California Energy Commission
Dockets Office, MS-4
Re: Docket No. 12-AAER-2
1516 Ninth Street
Sacramento, CA 95814-5512
docket@energy.ca.gov

RE: Invitation to Submit Proposals - 2012-2013 Appliance Efficiency Rulemaking Water Appliances – Docket No. 12-AAER-2C

Input to the California HCD Focus Group on proposed 2013 CALGreen changes with respect to water conservation.

Subject: 2013 CALIFORNIA GREEN BUILDING STANDARDS CODE CALIFORNIA
CODE OF REGULATIONS, TITLE 24, PART 11

Conservation Phase Lavatory Faucet Peak Flow Rate Distribution

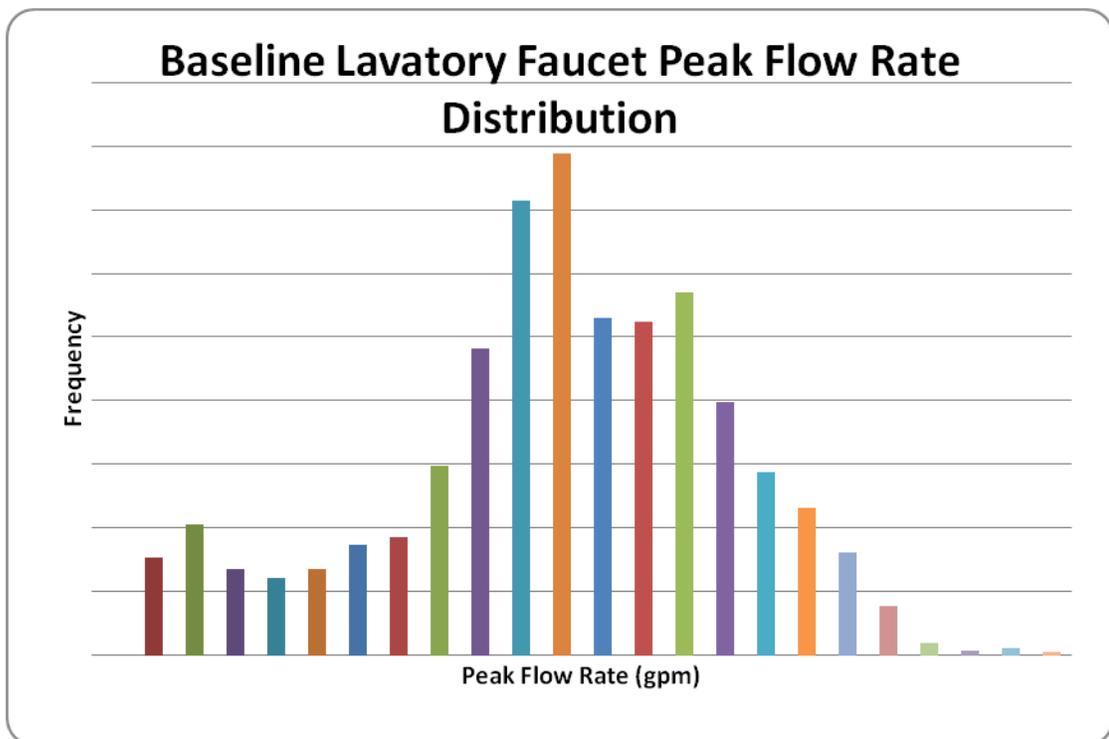
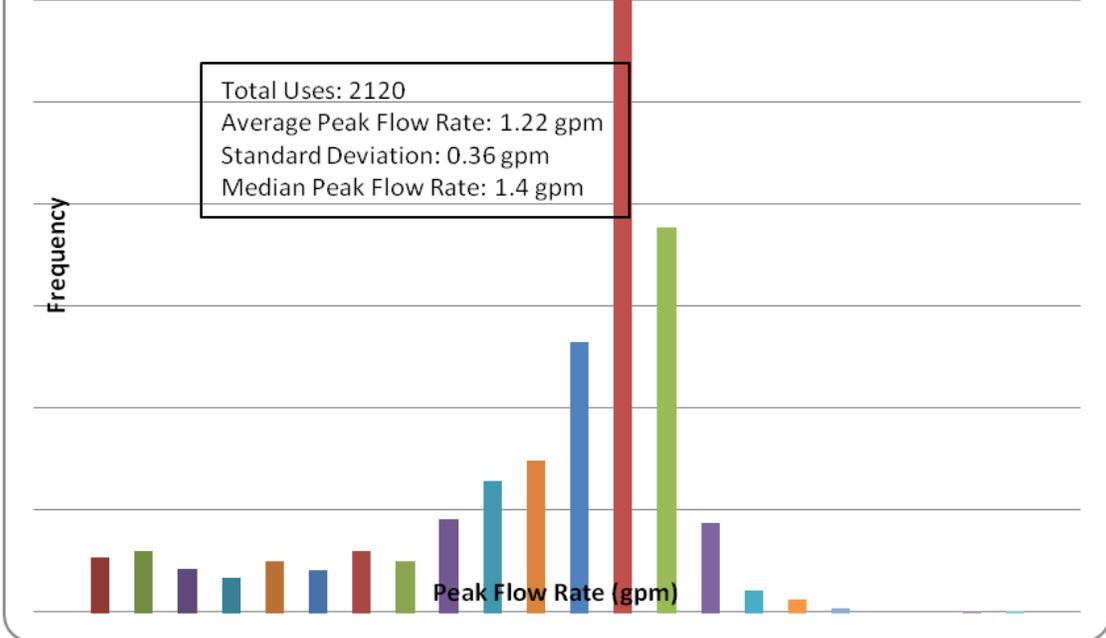
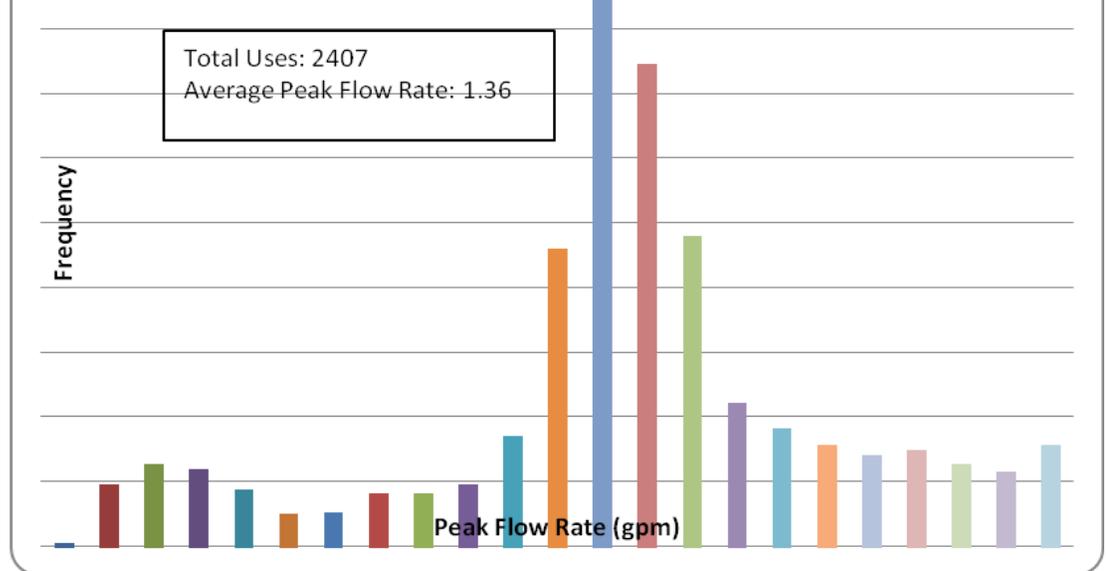
Our Home Water Use data suggest from the frequency/flow rate histogram that the average flow rate over the conservation phase of the study, where lavatory faucets were restricted to 1.5 gpm, was actually 1.2 gpm. The number of uses/capita/day average was 18.4 at an average time of 0.21 minutes/use: $(1.2 \times 18.4 \times 0.21 = 4.6$ gallons/capita/day average. The formula in the CALGreen table would calculate $1.8 \times 4 \times 1 = 7.2$ gallons/capita/day average, which significantly overstates the baseline value.

For kitchen faucets, the number of uses/capita/day was 3.4, at 0.24 minutes per use. Based upon the 2.2 gpm units in the study, the average flow rate per use was 1.36 gpm: $1.36 \times 0.24 \times 3.4 = 1.1$ gallons/capita/day. The CALGreen table baseline is: $1.5 \times .25 \times 3 = 1.125$ gallons/capita/day, which is not a significant difference from our Home Water use data.

3 – The missing piece is this draft proposal is the need for consumer research. The attached charts are a snapshot of real world consumer usage and have been used in the development of voluntary standards such as WaterSense.

For the above reasons, we would ask that the appendix on voluntary flow rate standards be removed from the 2013 CalGreen draft regulations.
